UNITED STATES PATENT AND TRADEMARK OFFICE

10/598,613

Office Action Summary	Application No. 10/598,613	Applicant(s) PEUKER ET AL.	
	Examiner JENINE PAGAN	Art Unit 3728

DETAILED ACTION

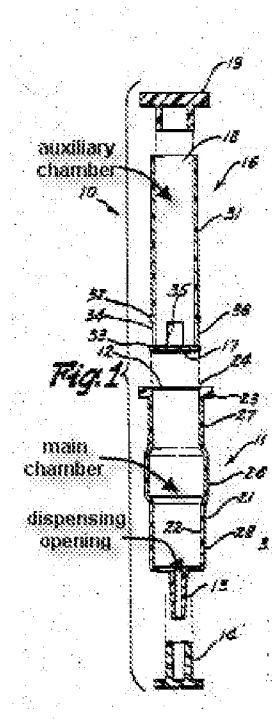
Claim 1/25: Pierick discloses a capsule body member 11 providing a main chamber (see figure above), and comprising a dispensing opening (see figure above), wherein the inner wall 22 of the capsule body member comprises a recessed area 26; an applicator member 16 adapted for slideable accommodation in said capsule body member, said applicator member providing an auxiliary chamber (see figure above), and wherein said applicator member comprises a through-hole 34/35/36 extending from the auxiliary chamber to the outer circumferential surface of the applicator member; and an activator member 19 being slideably accommodated in said applicator member; said through-hole and said recessed area forming a channel between said main chamber and said auxiliary chamber upon activation of said capsule due to movement of said

activator member towards said dispensing opening, causing movement of said applicator member due to hydraulic transmission.

Claim 2: Pierick discloses radially extending through-hole 34/35/36 in said applicator member 16 is initially covered by the wall 22 of said capsule body member 11. (Col 3:20-27)

Claim 3: Pierick discloses said radially extending through-hole 34/35/36 is located in close proximity to the separation wall 17 of said applicator member 16 separating said auxiliary chamber from said mixing chamber.

Claim 4: Pierick discloses said through-hole 34/35/36 extends essentially perpendicularly to the longitudinal axis of said applicator member 16.

Claim 8: Pierick discloses said applicator member 16 comprises a sealing element 32/33 sealing said through-hole 34/35/36 of said applicator member 16 against said recessed area 26 of said body member 11 and against the exterior of said capsule.
